## SUNSHINE COAST REGIONAL DISTRICT

### ADDENDUM NO.#2

Request for Proposal No. 2361301

Reconstruction Aquatic Centre Fire Sprinkler System

Figure 1: Section - Backwash and Surge Tank

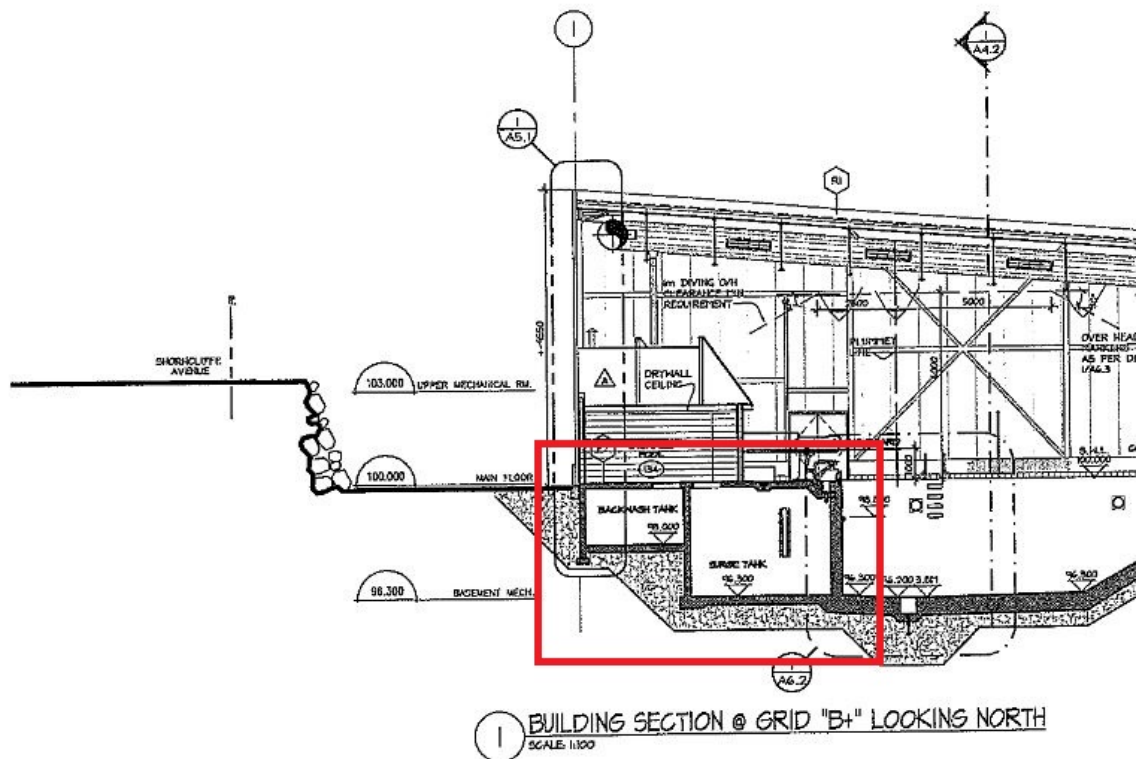
Allester Engineering (A.E.) has reviewed the provided structural and architectural drawings as well as the information regarding the Genie Boom Lift noted above. The lift may only be used on specific slab on grade areas of the pool deck. Due to the weight of the lift 2 layers of 3/4" plywood will be required to be used to protect the pool deck at all times. Please also note that there are areas of the pool deck that are suspended slab over the backwash tank and surge tank. These areas are unable to support the lift and should not be loaded at any time. Please review figures 1, 2, and 3 as well as the architectural and structural drawings for specific locations and communicate to the lift operator which areas of the slab should not be loaded. It would be advisable to mark these no-go areas with cones while the lift is in operation.

As a caveat A.E.'s review is based on the provided information and the assumption that the slab was installed on compacted subgrade as per drawing specifications. If there are voids or other construction deficiencies that we are unaware of, there could be potential cracking of the tile or slab. It is important to monitor the slab and tile during lift operation and cease operation if any damage is observed.
